UNITED STATES  
NUCLEAR REGULATORY COMMISSION  
WASHINGTON, D.C. 20555-0001

SUBJECT: FERMI 2 – STAFF ASSESSMENT OF RESPONSE TO 10 CFR 50.54(f)  
INFORMATION REQUEST – FLOOD-CAUSING MECHANISM  
REEVALUATION (TAC NO. MF1101)

STAFF ASSESSMENT BY THE OFFICE OF NUCLEAR REACTOR REGULATION  
RELATED TO FLOODING HAZARD REEVALUATION REPORT  
NEAR-TERM TASK FORCE RECOMMENDATION 2.1  
RELATED TO THE FUKUSHIMA DAI-ICHI NUCLEAR POWER PLANT ACCIDENT

FERMI, UNIT 2

**Figure 3.2-1: Site Map Showing Structures, Ground Surface Contour, Location of Cross Sections A, B, and C.**

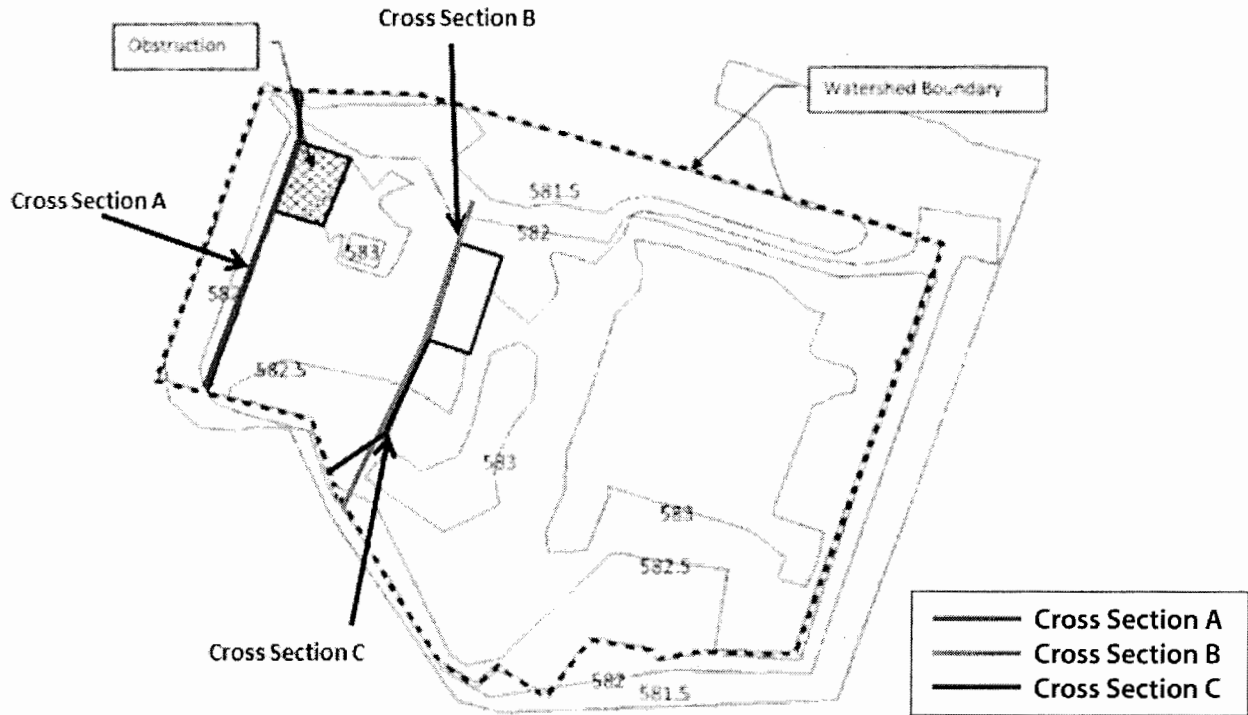
The licensee performed hydraulic analysis for the onsite drainage area using the rational method and Manning's equation. The analysis was used to determine the water surface elevation at three cross sections (A, B, and C), as shown in Figure 3.2-1. The flow rates calculated based on the rational method are 3,844 ft<sup>3</sup>/s (108.9 m<sup>3</sup>/s) for cross section A; 3,040 ft<sup>3</sup>/s (86.1 m<sup>3</sup>/s) for cross section B; and 268 ft<sup>3</sup>/s (7.6 m<sup>3</sup>/s) for cross section C. The licensee assigned a uniform base elevation and slope to each cross section and the estimated unobstructed section width, slope, base elevation and peak runoff are listed in Table 3.2-1. The

licensee used Manning's equation to predict a runoff depth corresponding to the flow rate at each cross section and determined the maximum water surface elevation is 583.4 ft (177.8 m) for cross sections A and B and 583 ft (177.7 m) for cross section C.

The elevation of the door sills for the class I structures is 583.5 ft (177.8 m). On the basis of sensitivity tests, licensee determined in the RAI response that the maximum water surface elevation at the cross section B will not exceed elevation 583.5 ft (177.8 m), even if the combination of the most conservative conditions is considered.

**Figure 3.2-2: Site Map Showing Structures, Ground Surface Contour, Location of Cross Section B and Drainage Areas for Cross Section B.**

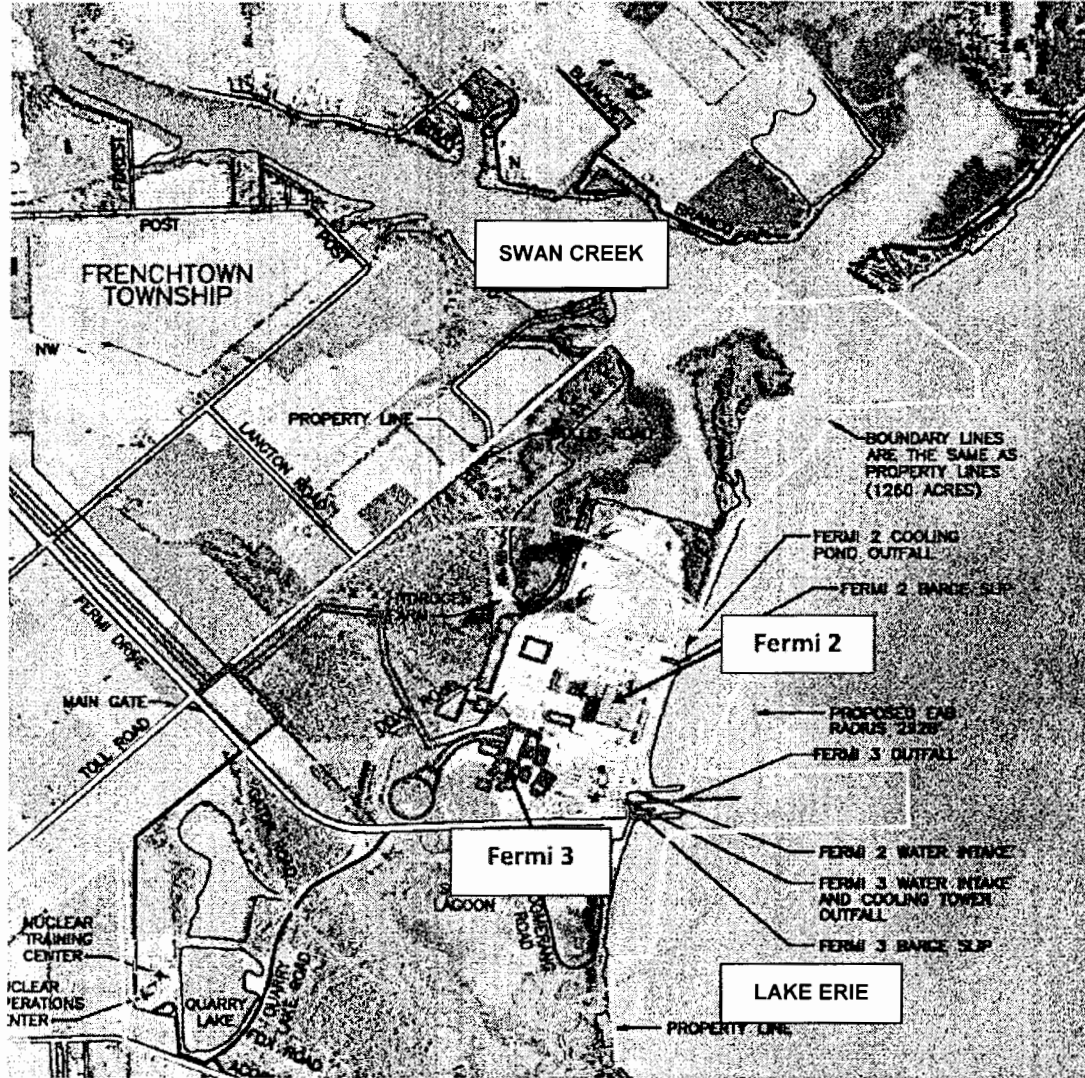
The staff reviewed the site elevation contour plot provided in the electronic reading room as a scanned electronic file and found that a uniform base elevation assigned to the cross sections A and C approximately reflects an average surface elevation along those cross sections. However, cross section B has a surface elevation that varies from slightly less than 582 ft (177.4 m) to nearly 583 ft (177.7 m). The southern part of cross section B, about 40 to 50 percent of its total unobstructed width, coincides with cross section C, which has a base elevation of 582.5 ft (177.5 m). Therefore, the average base elevation for cross section B is mainly between 582 ft (177.4 m) and 582.5 ft (177.5 m). The licensee's estimation assumes a rectangular cross section with a uniform water height over the base elevation. Under this rectangular assumption,

an average base elevation representing the varying bottom of the cross section would be reasonable. However, the licensee selected a low end of the base elevation instead of an average base elevation in its calculation, which results in an underestimation of water surface elevation. Staff issued an additional RAI (NRC, 2014c) requesting the licensee to provide (1) a rationale for using the low end of base elevation in its calculation, (2) supporting onsite ground surface elevation in native electronic format, and (3) the basis for the acceptance criterion of 583.5 ft (177.9 m) for the LIP analysis (RAI No.4).

As shown in Figure 3.2-2, the ground surface elevation varies along cross section B from 581.6 ft (177.3 m) at the northern end (in Figure 3.2-2, north is toward the top of the figure and south is toward the bottom), 582.5 to 582.8 ft (177.5 to 177.6 m) in the southern portion, and 582 ft (177.4 m) at southern end of cross section. A semi-trapezoidal shape with a bottom elevation ranging from 581.6 ft (177.3 m) at the northern end to 582.8 ft (177.6 m) at the southern end is considered as a conservative approach to represent the actual shape of cross section B. The water surface elevation can be estimated by water depth ( $d_1$ ) plus the base elevation (581.6 ft (177.3 m)) at the northern end or water depth ( $d_2$ ) plus the base elevation (582.8 ft (177.6 m)) at the southern end. The water depths ( $d_1$  and  $d_2$ ) are calculated by Manning's equation. The semi-trapezoidal cross section has a lesser flow area than the rectangular section (Table 3.2-2). The staff found that, for the same water surface elevation, 583.43 ft (177.8 m), as estimated by the licensee, the cross section flow area will be reduced by 15 percent from a rectangular to a semi-trapezoidal section at cross section B.

The extent of drainage area defined by the licensee for analysis at cross section B approximately follows the 581.5 to 582 ft (177.2 to 177.4 m) contour lines (Figure 3.2-2). The runoff generated from this area could flow to the west or east. As stated in FHHR, the concrete barriers erected since the initial issuance of the operating license could restrict surface drainage from leaving the site in the north and south directions. Thus, the licensee concluded, and the staff agrees, that it is reasonable to assume that no flow occurs across the north and south sections for the analysis. The licensee's analysis also included a conservative assumption that all runoff from the onsite drainage area of 34 acres flows towards the west of the site to cross section B. However, under this assumption, the resulting maximum water surface elevation at cross section B would slightly exceed the current design-basis flood elevation of 583.5 ft (177.9 m) because the actual cross section in the semi-trapezoidal shape has the less section area for flow to pass compared to the section in rectangular shape assumed by licensee.

In order to have a more realistic evaluation, staff reviewed the site aerial photography image combined with the ground surface elevation contours provided by the licensee. As shown in Figure 3.2-2, the area east (east is located on the right-hand side of Figure 3.2-2) of the main building structures has less restriction for flow across the site and the flow from this area could

directly discharge to the Lake Erie. On the basis of the contour map and building locations, staff identified a more realistic drainage area of 27 acres from which flow will mostly go to the west across cross section B. The drainage area for analysis along cross section B is shown in Figure 3.2-2 as the shaded area.

Staff applied the Rational Method for estimation of flow from the drainage area identified above and calculated the maximum water surface elevation by using Manning's equation with an assumption of semi-trapezoidal shape representing cross section B. The other parameters in Manning's equation, such as Manning's roughness coefficient (n) and slope (S) entering to cross section B, remain the same in the staff's calculation as in the licensee's. The results are summarized in Table 3.2-2. The resulting maximum water surface elevation at cross section B is 583.44 ft (177.83 m), which is below the acceptance criterion of 583.5 ft (177.9 m). As a comparison, the results from the licensee's analysis for cross section B are also listed in Table 3.2-2.

On the basis of an independent review and of the licensee's assertion that the elevation of the door sills are above plant grade, the staff confirmed the licensee's conclusion that the reevaluated flood hazard for LIP and associated site drainage would not exceed the elevation of the door sills.
